APPENDIX 3

Appraisal Data

The research data presented below features information from community appraisal of disability access at railway stations in the City of Yarra. Records about each station are presented in individual tables with description of the current level of compliance, suggested improvements and other commentaries and images, which are referenced against the eight accessibility categories (TGSi, shelter at WAP, ramp gradient, ramp width, WAP, handrails, signs, accessible parking bays) and against potential hazards. In some instances an additional row is added as 'other improvements', when more opportunities for better accessibility, beyond the listed categories, has been observed. For terminology and abbreviations please refer to *Section 2 Key Findings* and to *Appendix 2 Glossary* in the main report (pp. 6 and 16).

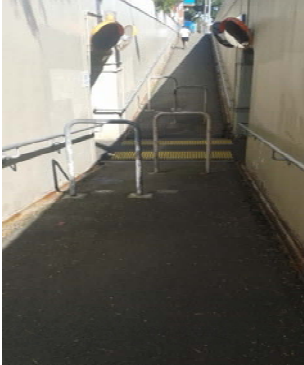
TABLE 2. CLIFTON HILL STATION APPRAISAL RECORD			
Category	Compliant	Needs Improvement	Image/Commentary
	storage area.	<p>hill is an interchange station and used by many.</p> <ul style="list-style-type: none"> Capacity has been identified for construction of 3 additional bays at north of P1 where there is more parking 	 <p>Below is PTV land where some more accessible parking bays could be installed.</p> 
Hazard		<ul style="list-style-type: none"> Footpath Bollards/Barrier hoops. These bollards do not allow enough room for scooters, double prams and some wheelchairs. There is a space of 92 cm in 	<p>Footpath Bollards can be an obstacle for people with vision loss; and they are difficult to navigate around for people with twin prams, wheelchairs and scooters.</p>

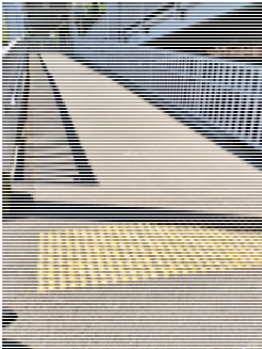
Hazard		<ul style="list-style-type: none"> Pedestrian crossover access is too steep. This needs to be recommended for Yarra City Council to fix. 	<p>This is a photo of a person using an electric wheelchair getting stuck on footpath crossover due to steepness of crossover. The front footplates are scraping the ground and could cause a wheelchair to topple over. This footpath crossover requires YCC to eliminate danger and modify crossover.</p>

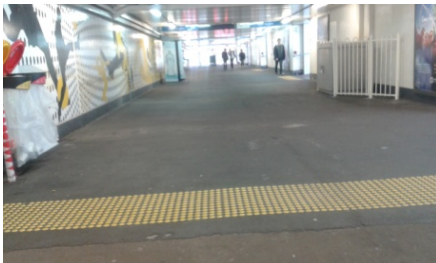
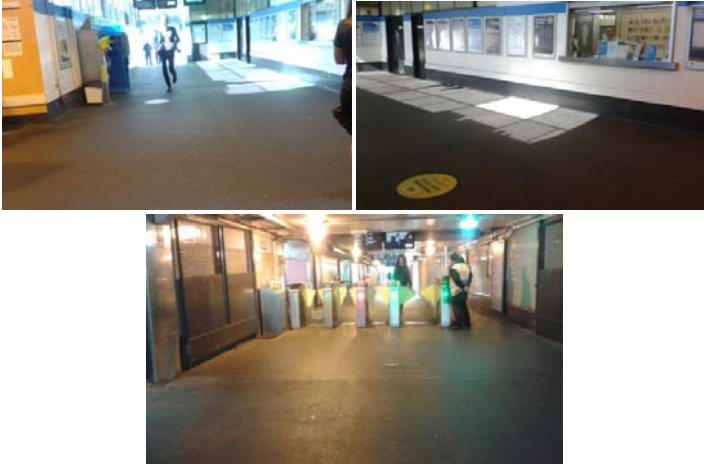
TABLE 6. RICHMOND STATION APPRAISAL RECORD			
Category	Compliant	Needs Improvement	Image/Commentary
			<p>Lack of TGSI directional way finder from Sports Subway Swan street.</p>  <p>Worn out TGSI at top and stairs.</p>  <p>Worn out and low contrast of TGSI on ramp. Replace with high colour contrast TGSI.</p>

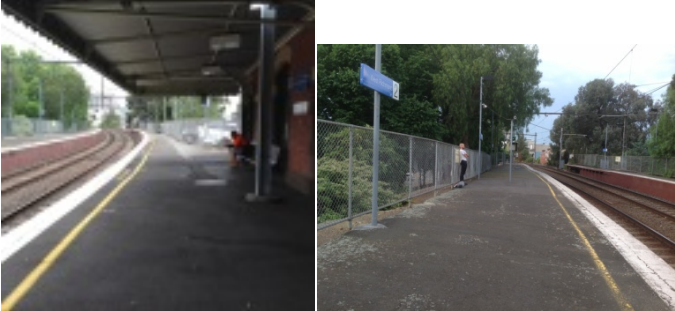
TABLE 9. WEST RICHMOND STATION APPRAISAL RECORD			
Category	Compliant	Needs Improvement	Image/Commentary
TGSI	TGSI on platform 0/2 TGSI on Entrance 0/2 TGSI on Ramps 0/1	<ul style="list-style-type: none"> TGSI required on P1 & 2 platform edge 0/2 Requires TGSI o P1 & 2 at entrance 0/2 	<p>Platform 1 & 2 requires the installation of TGSI along edge of platform.</p>  <p style="text-align: center;">Platform 1 Platform 2</p> <p>Platform1 & 2 requires the installation of TGSI at Station entrance.</p>  <p style="text-align: center;">Platform 1 Platform 1 Platform 2</p>
Shelter at WAP	Compliance 0/2	<ul style="list-style-type: none"> Shelter at WAP required on P1 & P2 	<p>Platform 1 & 2 require the installation of Shelter at WAP</p>

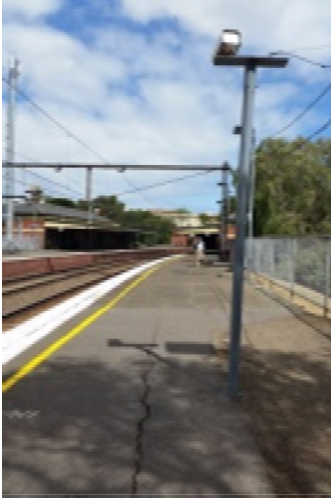
TABLE 10. TARNEIT STATION APPRAISAL RECORD			
Category	Compliant	Needs Improvement	Image/Commentary
TGSI	TGSI Compliant 2/2 TGSI also in front of lift, stairs, ramps and on platforms.	<ul style="list-style-type: none"> • GSI are different colours, it would be better to have consistency. • Directional TGSI in front of elevator requires is required linking to the other areas of train station. • The pathway through the main entrance at reception to platform requires TGSI to maintain a continuous pathway. Install TGSI on other side of double doors, directional TGSI externally from door to platform and internally across main entrance to double doors. The installation of TGSI in reception area may also be useful, • Install directional TGSI pathway from P 1 & P2 towards pathway to car park and bus stops, 	<p>TGSI on P 1 & P2 has great colour contrast along the platform edge.</p>  <p>TGSI have been placed at top and bottom of stairs and ramps indicating start and finish points. The photos also show the yellow directional TGSI which guides the way to platform.</p>

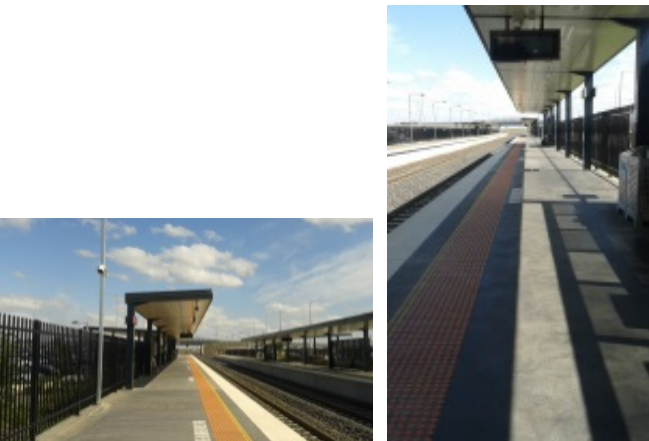
Category	Compliant	Needs Improvement	Image/Commentary
			<p>TGSI are absent at pick up points.</p> 
<p>Shelter at WAP</p>	<p>Shelter at WAP 2/2 Both, P 1 & P2 have shelter area on platform. Fully enclosed indoor waiting room as well.</p>		<p>Both Platform 1 and 2 have ample shelter from sun and rain at wheelchair access boarding points.</p>  <p>The fully indoor waiting room is great protection from heat, cold weather and wind (see overpage).</p>

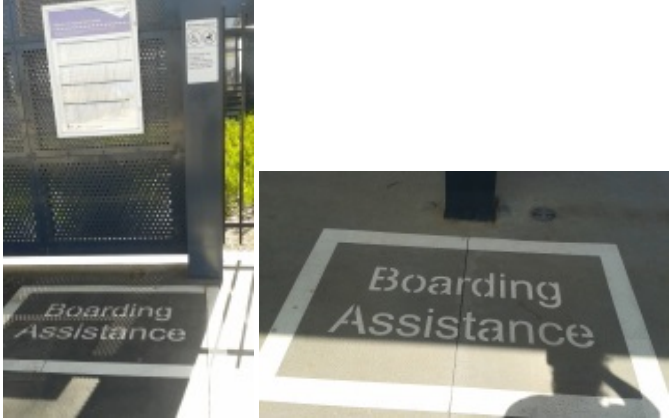
Category	Compliant	Needs Improvement	Image/Commentary
	<p>Signage on platforms and reception is excellent.</p>		<p>would be nice to have illuminated signs that could be read easily at the night.</p>  <p>The customer service signage is large enough for easy reading.</p>
